City of  
Peterborough

# Memorandum

File: 15T-14502/Z1418SB

**SUBJECT:** Proposed Revisions to Application for  
Draft Plan of Subdivision 15T-14502  
2131222 Ontario Inc.  
821, 825 and 829 Lily Lake Road

REVISED  
**DRAFT PLAN OF SUBDIVISION**  
**14T-14502**  
**LILY LAKE ESTATES**  
PART OF LOT 11, CONCESSION 1  
GEOGRAPHIC TOWNSHIP OF SMITH, NOW IN  
CITY OF PETERBOROUGH  
COUNTY OF PETERBOROUGH

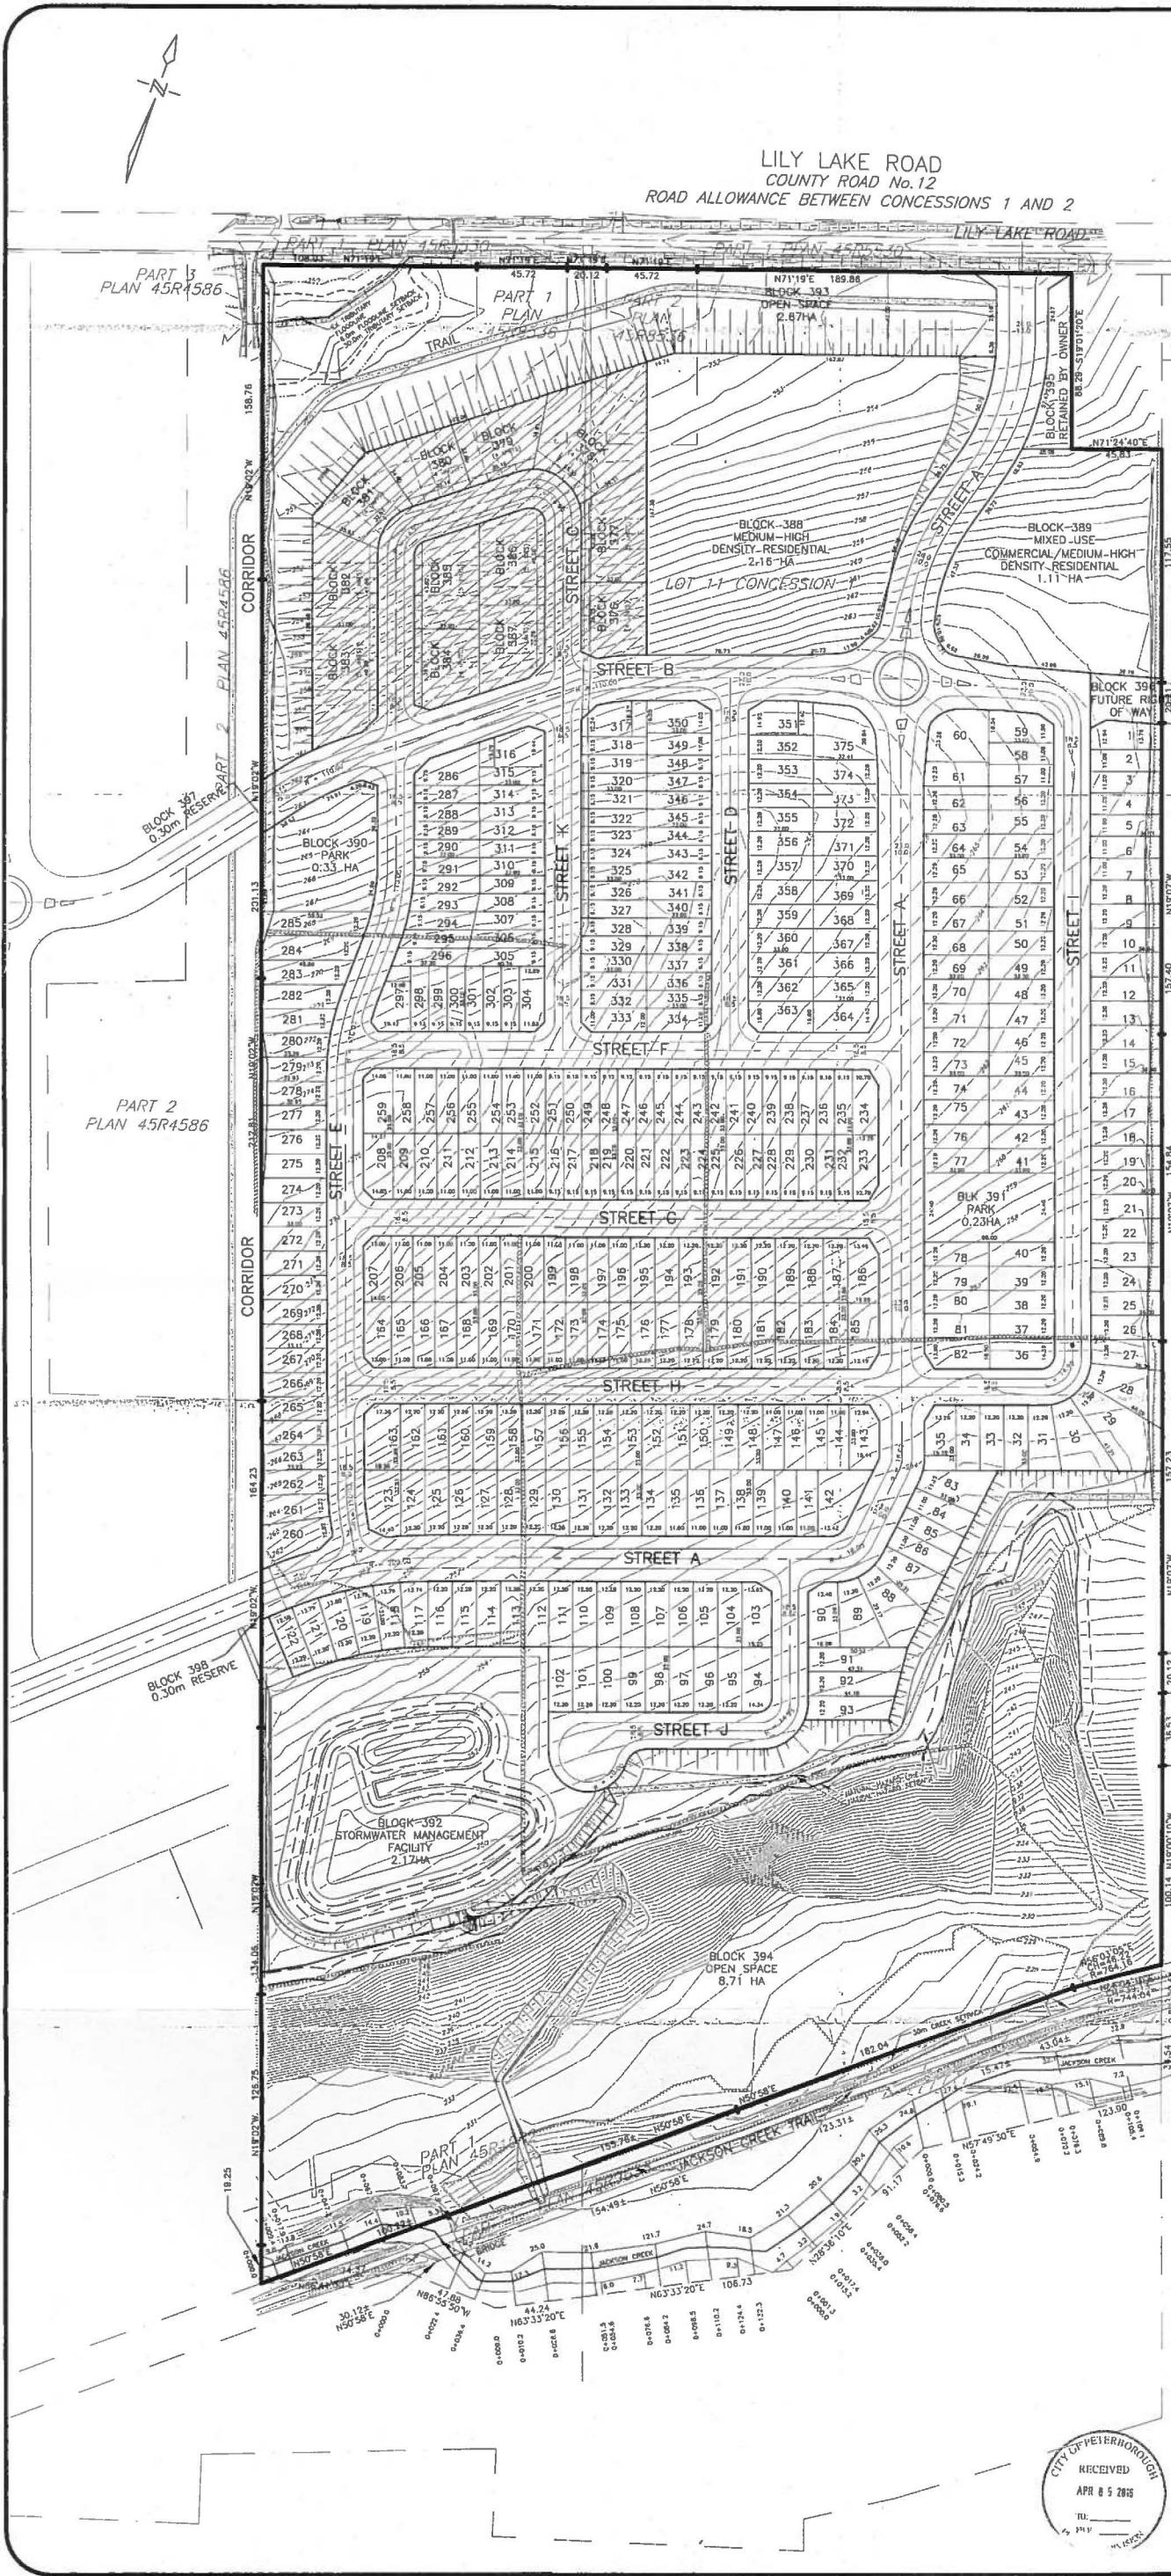
In response to agency and public comments received, the applicant has submitted a revised draft plan of subdivision application that:

- Adds a roundabout to the intersection of Streets A and B;
- Realigns Street B to align with previously planned streets to the east;
- Moves the potential elementary school site to the north side of Street B, at the west limit of the plan;
- Moves the potential medium-high density residential block to the intersection of Streets A and B;
- Shifts the proposed commercial block to a new mixed-use commercial/medium density residential block on the east side of Street A;
- Shifts parkland from the east limit of the plan on Street B to the west limit of the plan on Street B to align with the proposed north-south open space corridor;
- Includes a small parkette between Streets A and I;
- Incorporates a series of north-south streets, south of Street B;
- Illustrates a conceptual trail network;

- Shifts the proposed stormwater management pond to the southwest corner of the site, above the Jackson Creek Valley;
- Introduces a single-sided cul-de-sac along the top of the Jackson Creek Valley
- Shifts a proposed north-south open space/trail corridor along the west limit of the site mostly onto adjacent lands to the west; and,
- Proposes lots with a minimum width of 12m or 40 feet along Collector Street A.

The proposed plan now illustrates:

- 375 lots for single detached residential purposes;
- 53 street-fronting townhomes (if not used for school purposes);
- 176 medium density residential units;
- 50 medium density residential units combined with a potential 700 square metre commercial plaza;
- an elementary school;
- two parkland sites;
- open space lands within the Jackson Creek Valley and along Lily Lake Road;
- a stormwater management pond; and,
- a potential street connection to the east.
